SUBJECT: Contract 8078, I-5 Columbia River Bridge Temporary Pile Test Program
CO #002 – UHMW Rollers Credit

CONTRACT NO: 008078 FEDERAL AID NO:
CONTRACT TITLE: I-5, COLUMBIA RIVER BRIDGE TEMPORARY PILE TEST PRO
CHANGE ORDER NO: 2 UHMW ROLLERS - CREDIT

Contract 8078
Change Order No. 2
Sheet 4 of 4

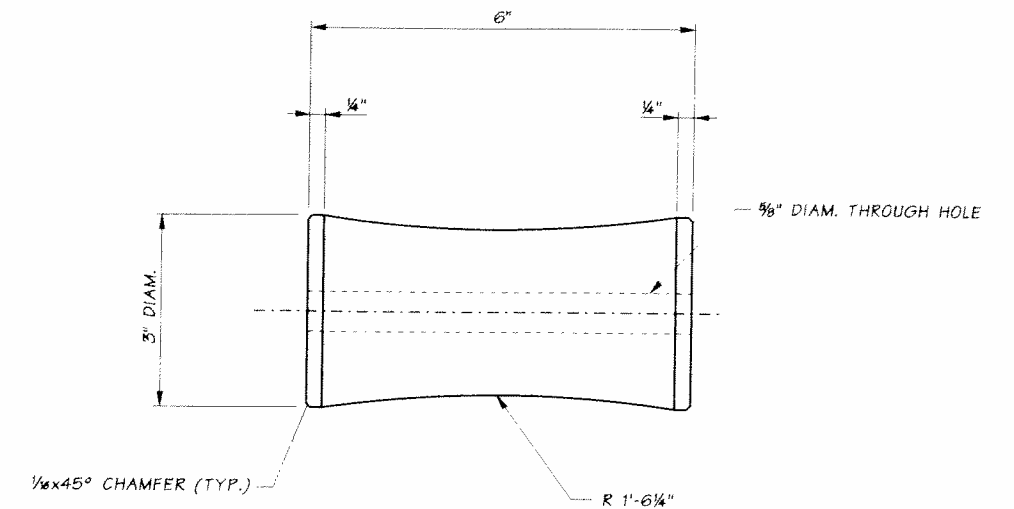
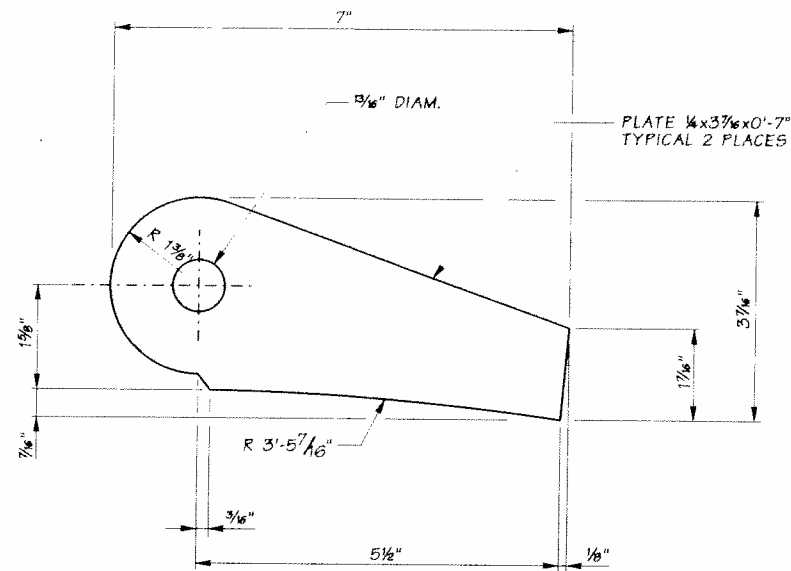
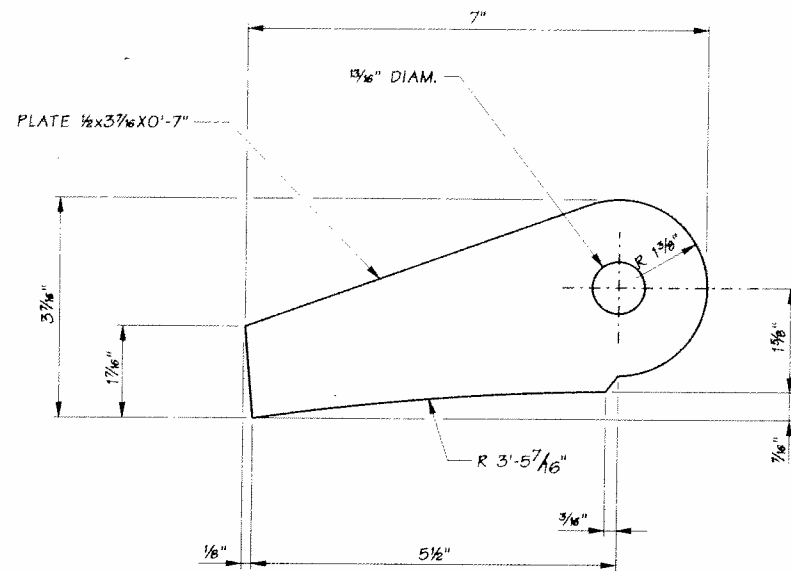
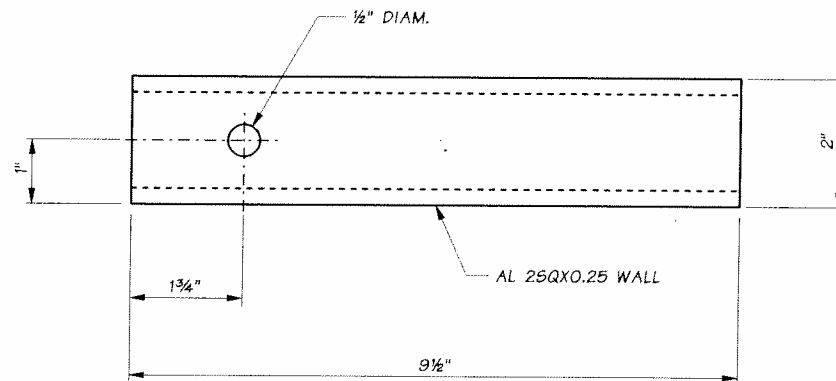
Attached for your review and further processing is Change Order No. 2. This change order allows the use of Ultra High Molecular Weight Polyethylene (UHMW) in lieu of the contract specified AASHTO Grade 60 Neoprene for fabrication of rollers for the Bubble Curtain System as shown on sheet 4 of 4 of this change order.

This change order allows the Contractor to substitute Ultra High Molecular Weight (UHMW) Polyethylene in lieu of the contract specified AASHTO Grade 60 Neoprene for rollers as shown on sheet 4 of 4 of this change order.

2 2
ND2 ND3
DETAIL
TYPICAL ROLLER
MATERIAL: ULTRA HIGH MOLECULAR WEIGHT POLYETHYLENE
